URBAN DESIGN COMMITTEE

URBAN DESIGN COMMITTEE STAFF REPORT

APPLICATION NUMBER	Urban Design Record #24002
APPLICATION TYPE	Neighborhood Design Standards Appeal
ADDRESS/LOCATION	4207 Pioneers Boulevard
HEARING DATE	February 06, 2024
ADDITIONAL MEETINGS	-
APPLICANT	Richard Gruenemeyer, rdjhn3vs16g@yahoo.com
STAFF CONTACT	Arvind Gopalakrishnan, 402-441-6361, agopalakrishnan@lincoln.ne.gov

URBAN DESIGN COMMITTEE STAFF REPORT

GRUENEMEYER HOME - SITE PLAN VIEW
4207 PIONEERS BLVD
LINCOLN, NEBRASKA

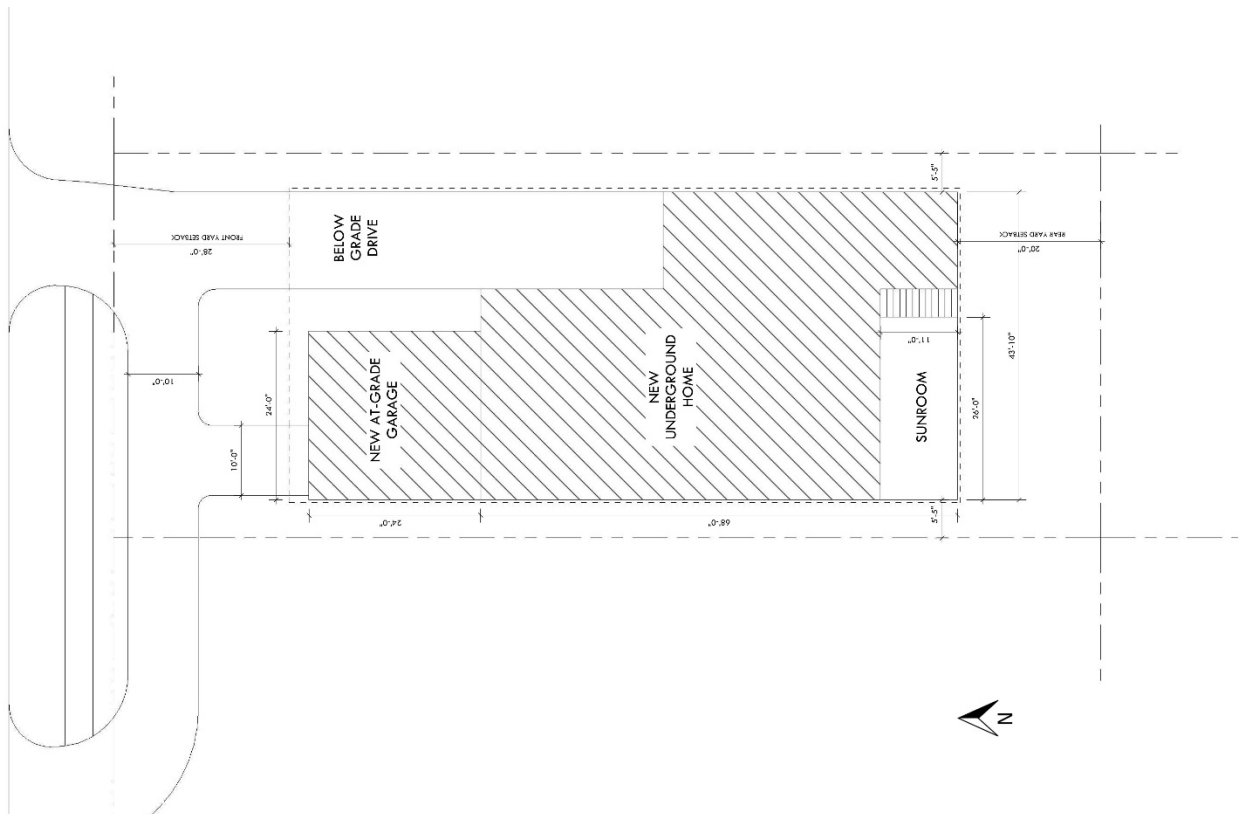
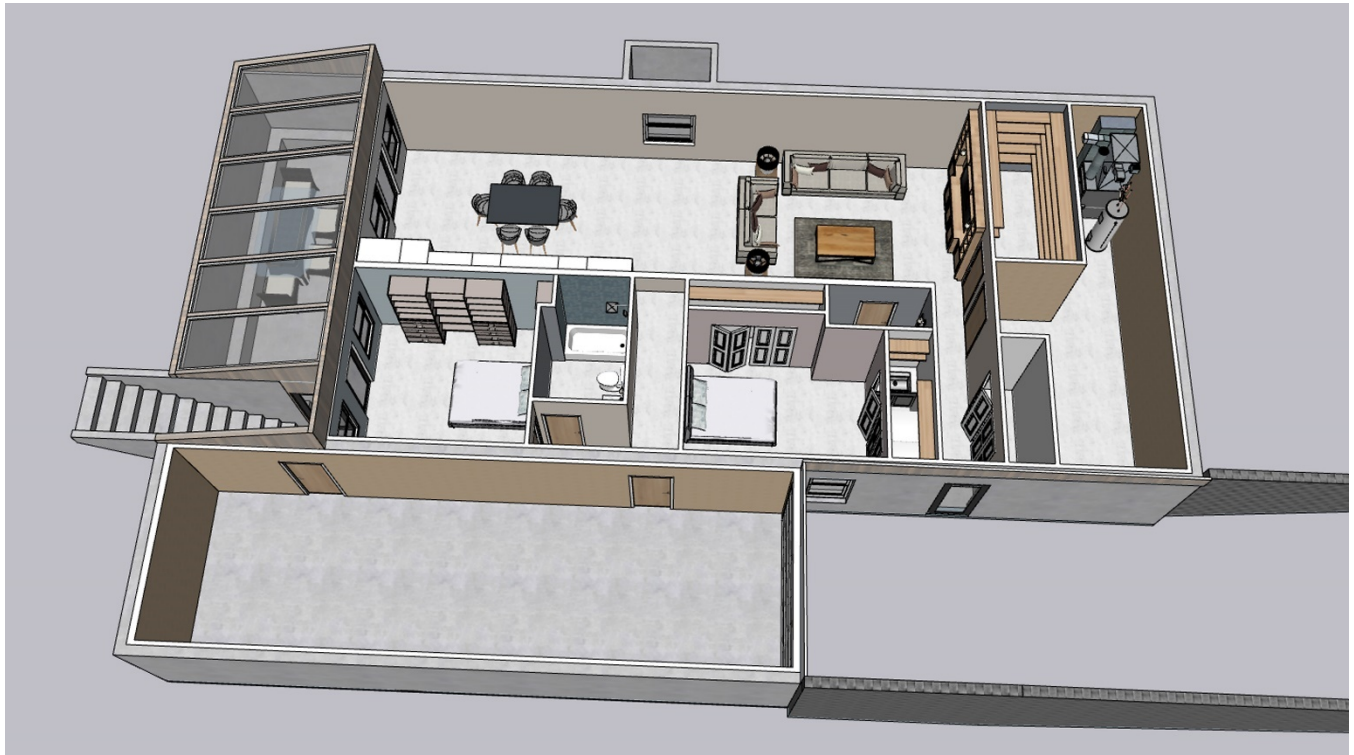
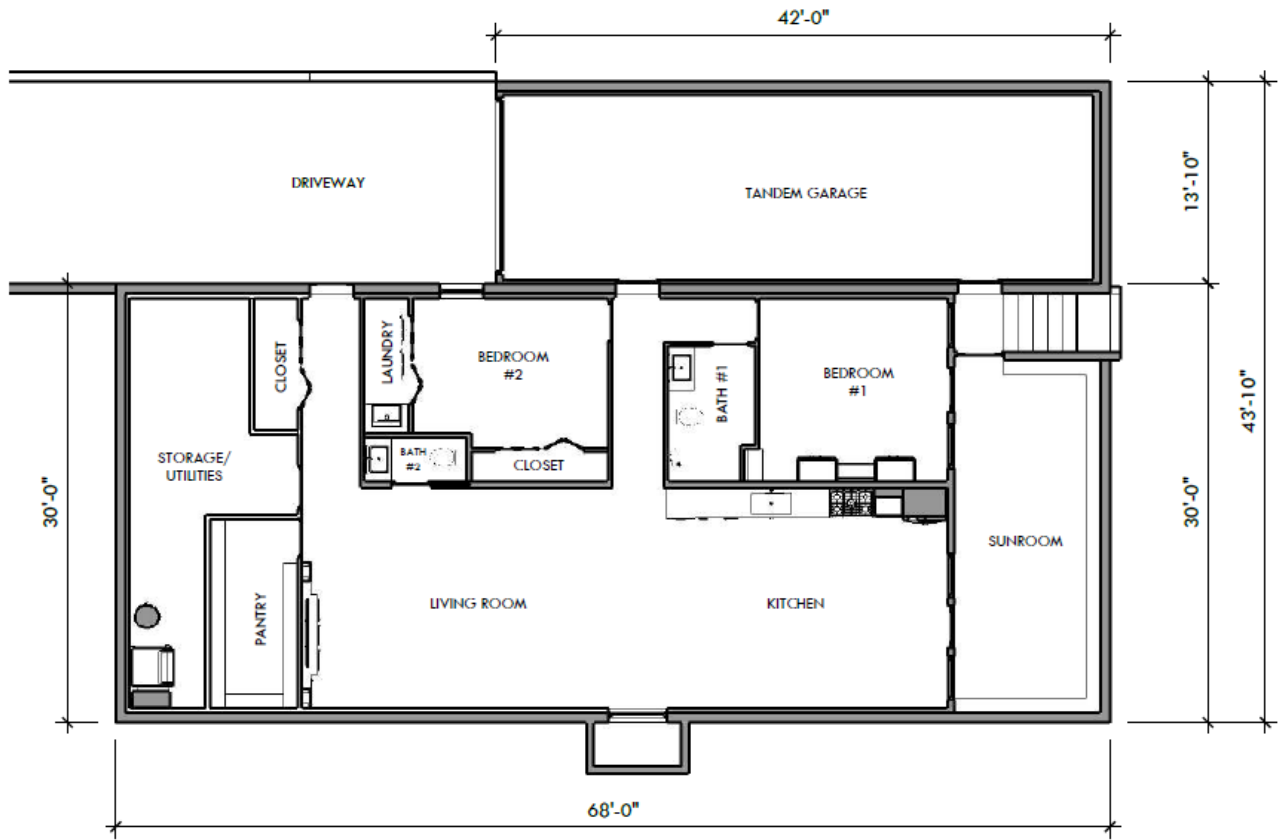
Compatibility per Staff Analysis: *No existing trees are being cut down for this construction. However, the proposal shows a tree that would be planted between the driveway and the sidewalk, to blend with the existing pattern of trees on the block.*

- I appreciate the inclusion of a tree and other landscaping in the plan. They help the structure look more settled in the larger landscape. I encourage the new owners to plant even more after they have finished the project to enhance the overall appearance.

ATTACHMENT B – Elevations

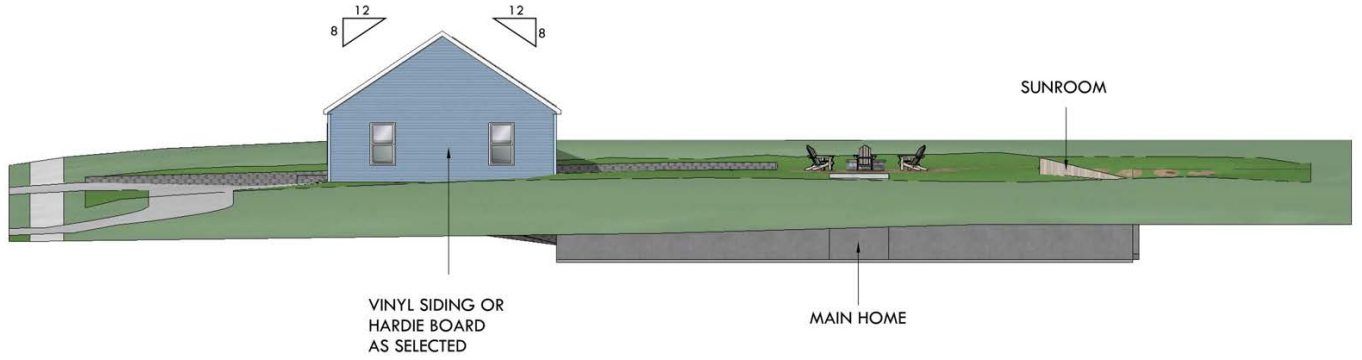
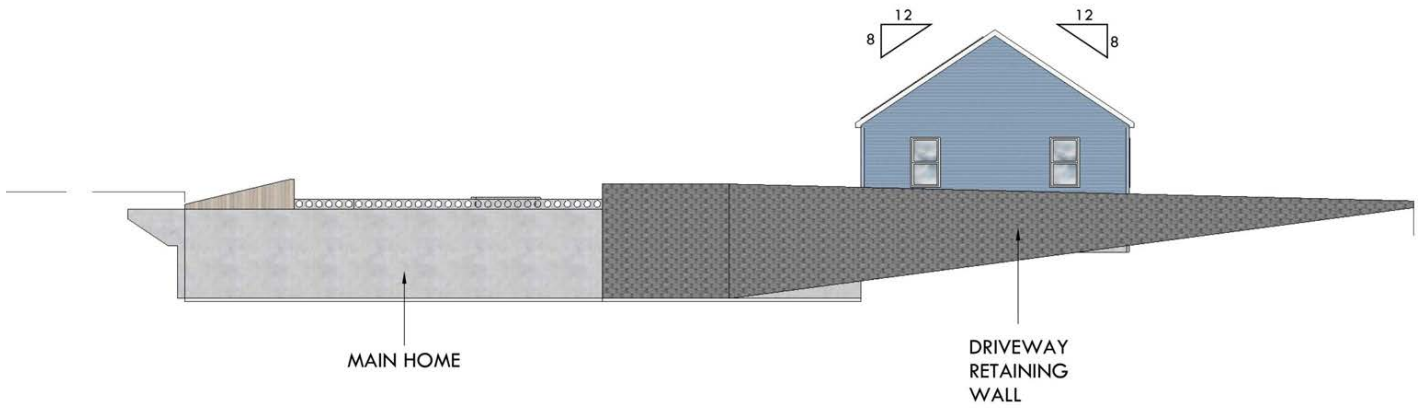
Garage doors do not count as openings. Apart from the garage door, the structure has a door, and a double-hung window fronting the street.

The top panel of the garage door would have two plexiglass panels, and the rest of the garage door would be painted to look like windows and shutters.

- The inclusion of faux windows and shutters on the garage door is unnecessary and detracts from the overall appearance. As the staff comments say, the faux shutters could be painted over so they are not a permanent design feature. Further, it appears that the only requirement is that there be at least one window and one door facing the street which would be met without the faux windows. There is a paved driveway running up to the garage door so the faux windows are not particularly effective at tricking the eye. I would recommend the garage door be opaque instead.

ATTACHMENT C – Landscape Plan

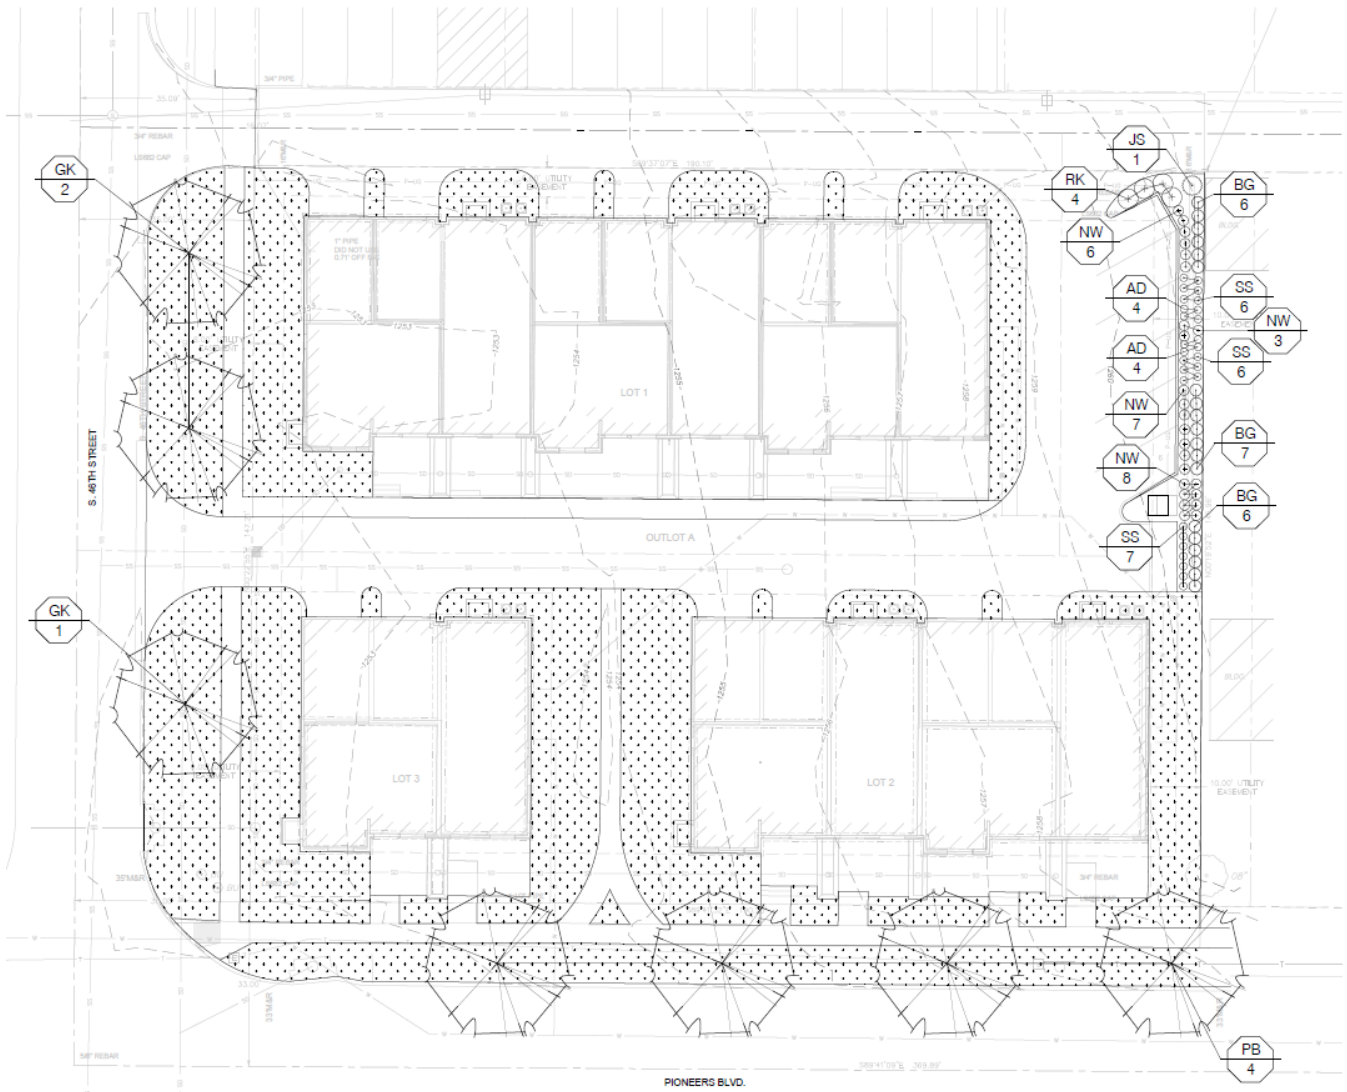
The landscape plan (**attachment C**) shows 4 Bloodgood London Plane trees along Pioneers Blvd, and 3 Kentucky Coffee trees along S 46th Street. Other shrubs and grasses east of the 6-plex are as shown in the plan and the plant schedule.

Compatibility per Staff Analysis: *No street trees are being cut down for this construction. However, the proposal shows 7 trees that would be planted as part of the project: 4 along Pioneers Boulevard, and 3 along 46th St., to blend with the existing pattern of trees on the block.*
